HV 844-N
Edition: 11/02

Publ.-Nr.:
599 51 37-57
685
EN

**Washing machines,
frontloading**

**EWM2000
Software
W2C01450**

Cotton 40 A-A / 40-60 MIX

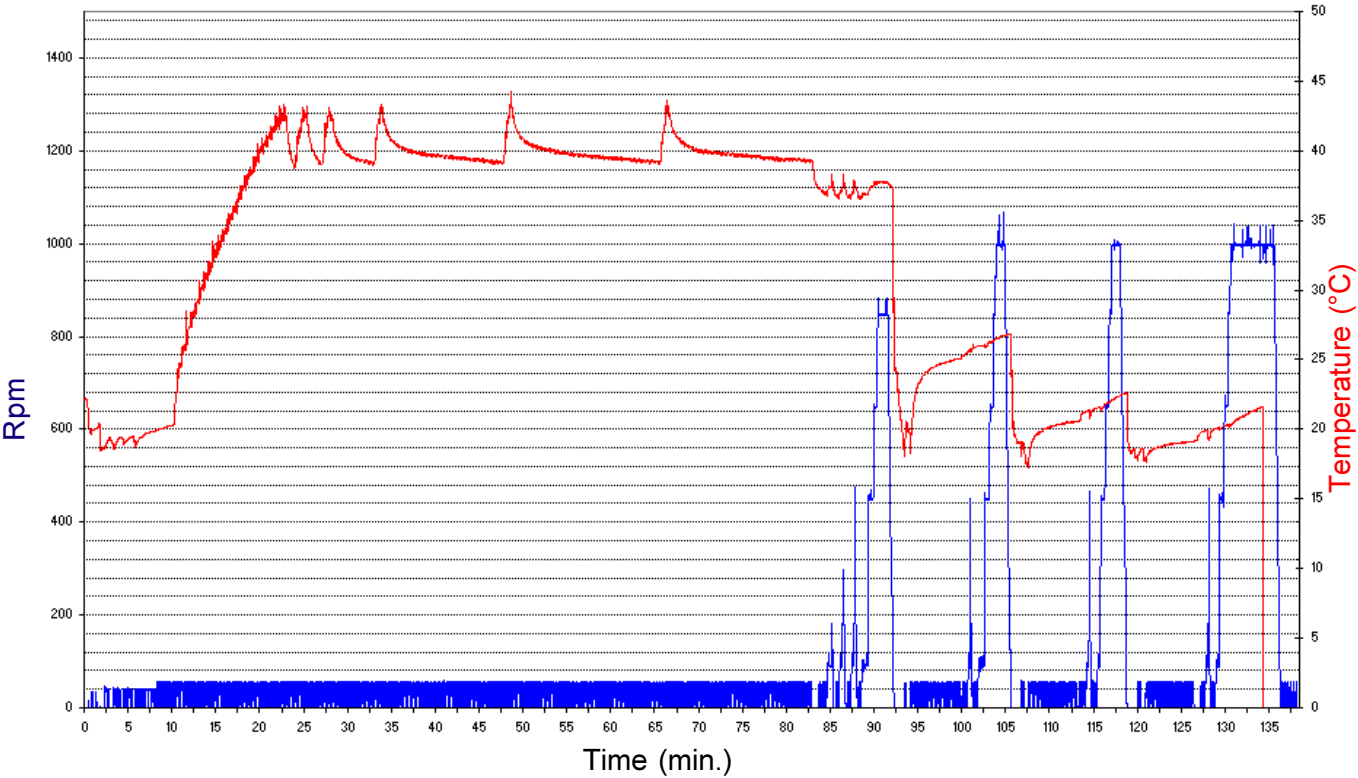
Cotton A/A 40° / 40 - 60MIX

- The washing performance and the energy-label increased to "A".
- The temperature and the mechanics have been coordinated.
- By using lower temperature the length of the washing cycle increased.
- The cycle duration is about 140 min.
- The replacement of the electronic EWM2000 and the user-interface unit in devices with software W2C01352 / W2C01353 will change the cotton/coloured 40°C program to 40 A/A / 40 - 60 MIX.

Night-Cycle

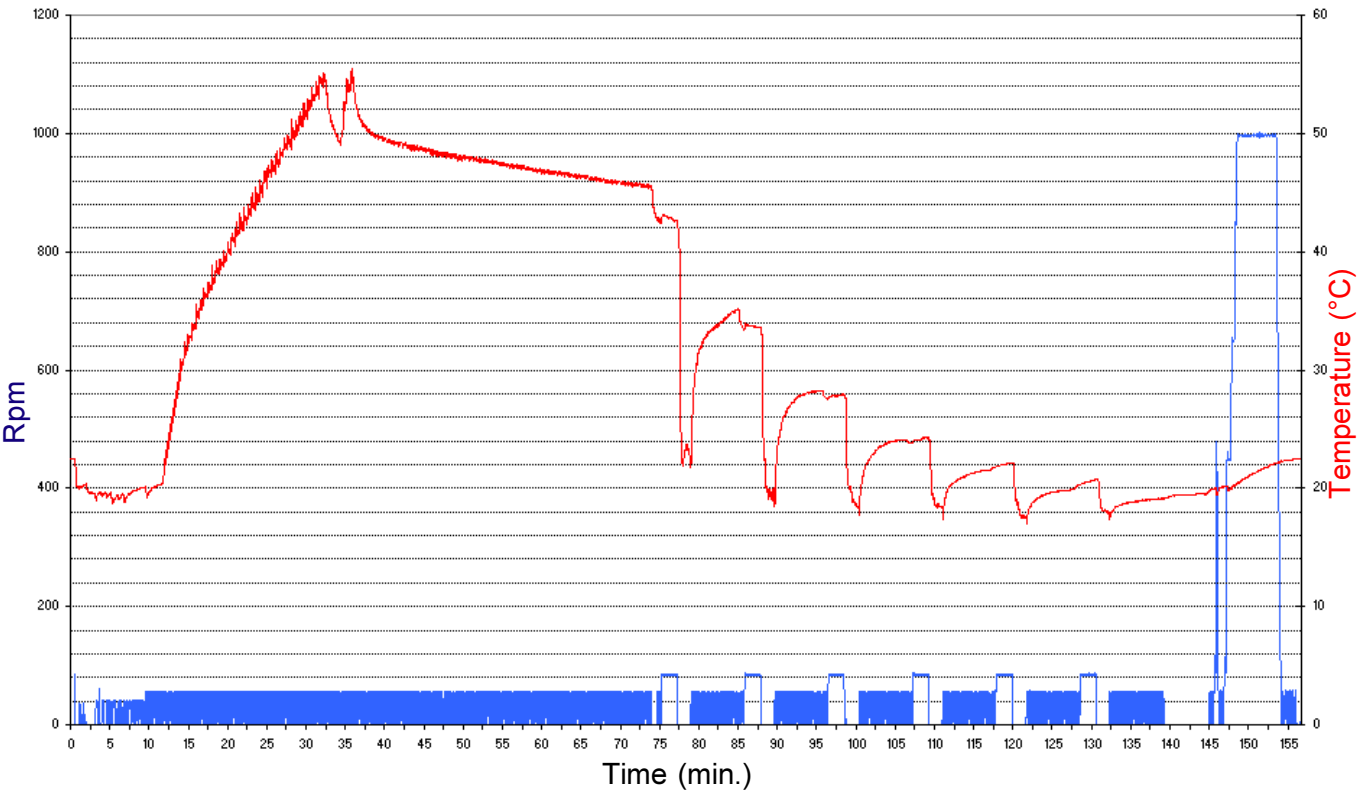
Night cycle

- This function is available for all cotton and synthetic cycles.
- Depending on device version, this function can be selected via the spinning key or a separate key.
- The number of rinses increased from 3 to 6 rinses. All rinses are without a spin phase.
- The program ends with rinse hold.

Cotton 60° Extra-Quick

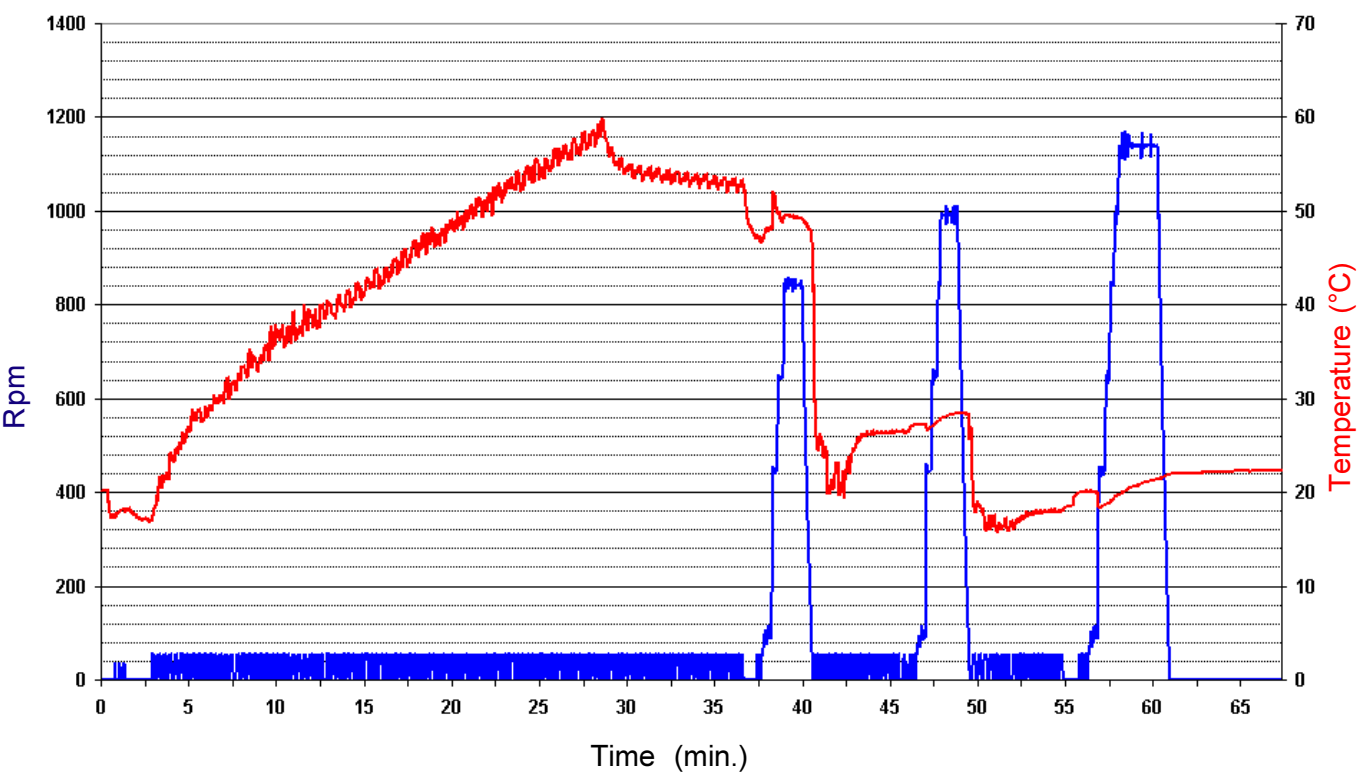
Extra quick for cotton 40° - 60°

- Very quick program (duration of cycle is about 60 min.) for daily worn laundry.
- The washload is 3,5kg (average household load).
- The number of rinses increased from one rinse to two rinses.
- The program cotton/linen 50° is not longer to combine with the option quick or time-saving.
